WINSOME FILING NO. 3  
PRE DEVELOPMENT GRADING AND EROSION CONTROL PLAN  
A PORTION OF SECTIONS 13 AND 24, TOWNSHIP 11 SOUTH, RANGE 65 SOUTH, AND  
A PORTION OF THE WEST HALF SECTON 19, TOWNSHIP 11 SOUTH, RANGE 64 WEST OF THE 6TH P.M  
COUNTY OF EL PASO, STATE OF COLORADO

# Grading & Erosion Control Plan\_V2-redline.pdf Markup Summary

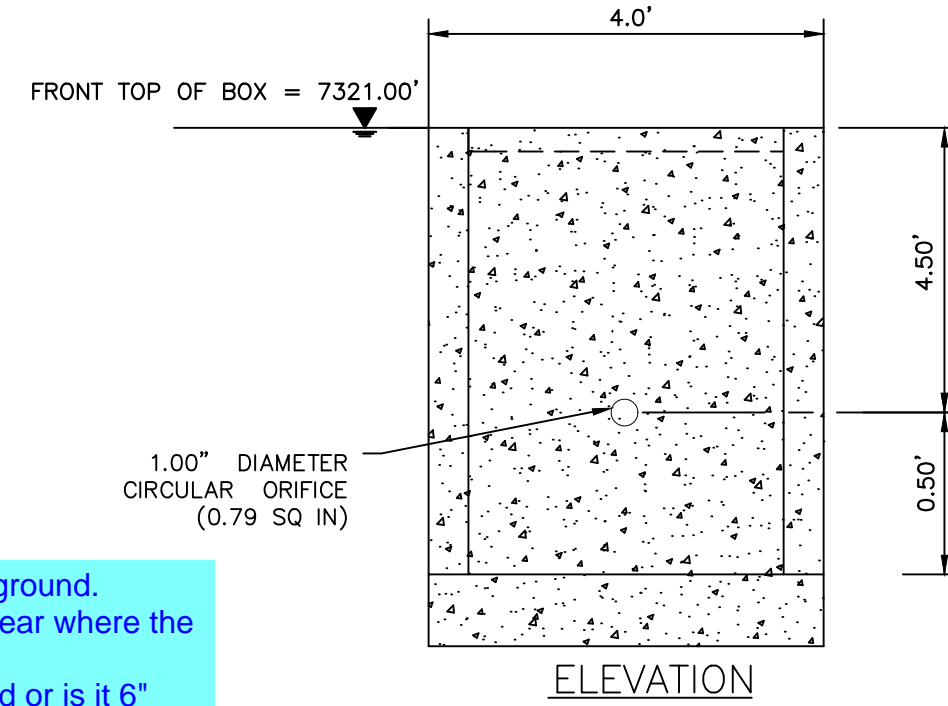
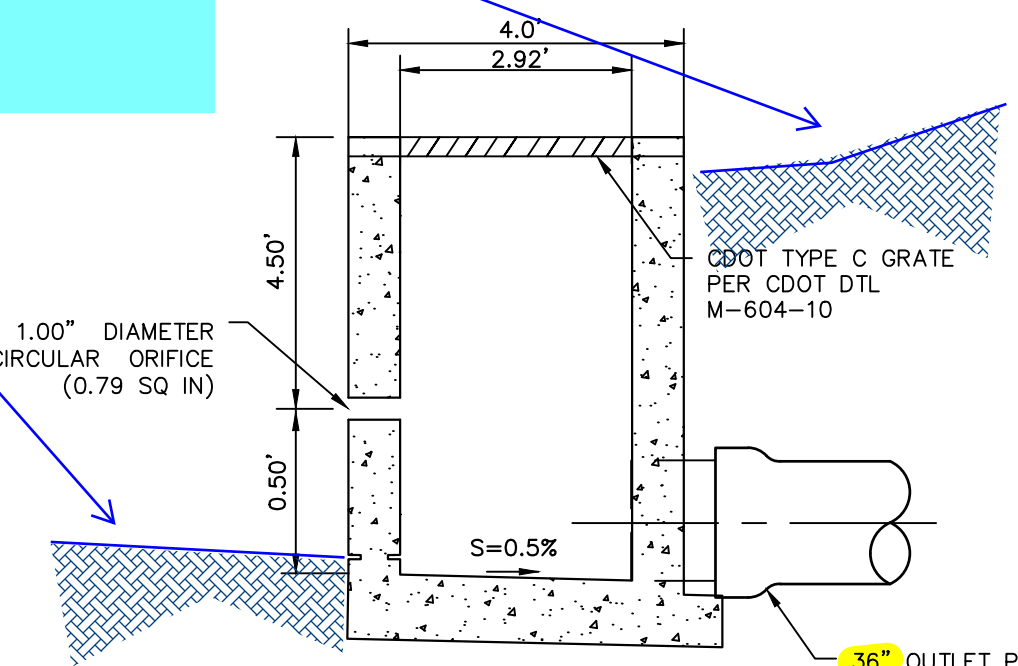
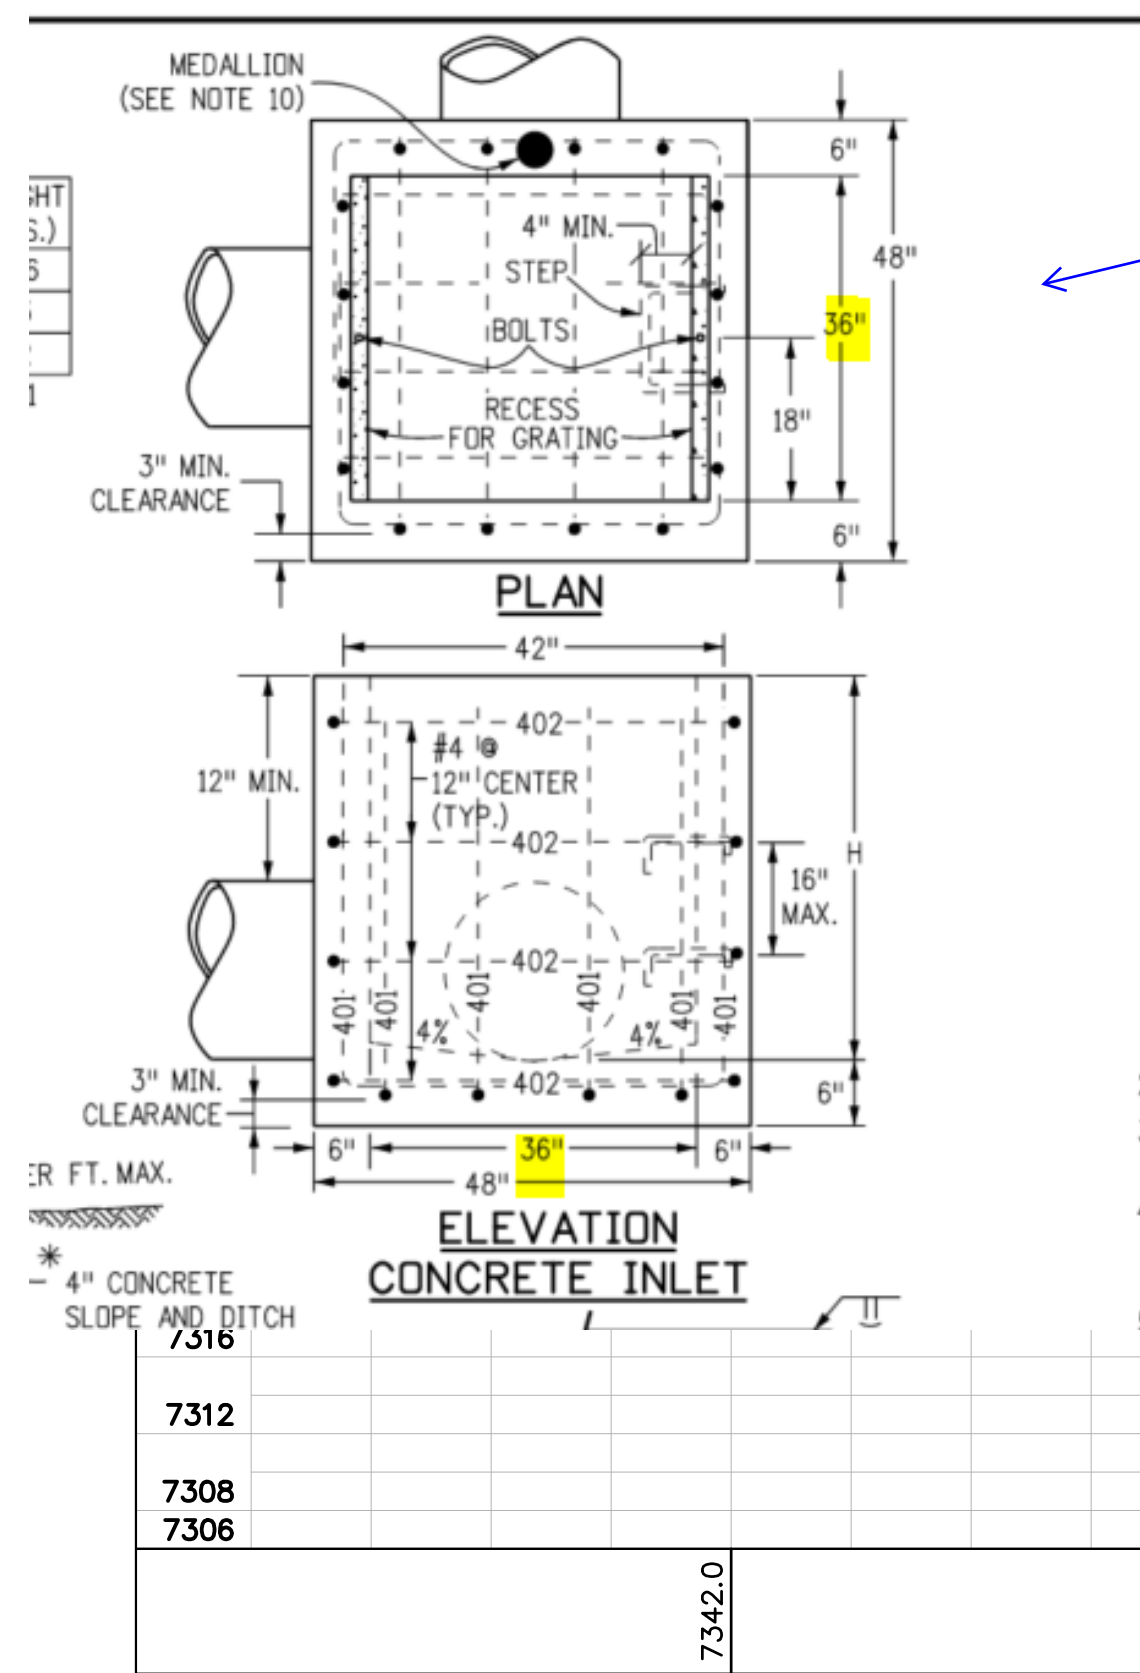
Show the existing and/or proposed ground. Neither this sheet or sheet 1.13 is clear where the structure is relative to the ground. i.e. is the orifice flush with the ground or is it 6" above the ground.

Provide a plan view of the Type C detail. Min wall thickness for 30" Class 3 RCP is 4.25" for a total pipe diameter of 38.5". This is larger than the 36" inside wall dimension of a Type C inlet. Unclear how these would connect. Provide additional detail.

Sheet 1.13 shows 30" RCP. Update detail to match.
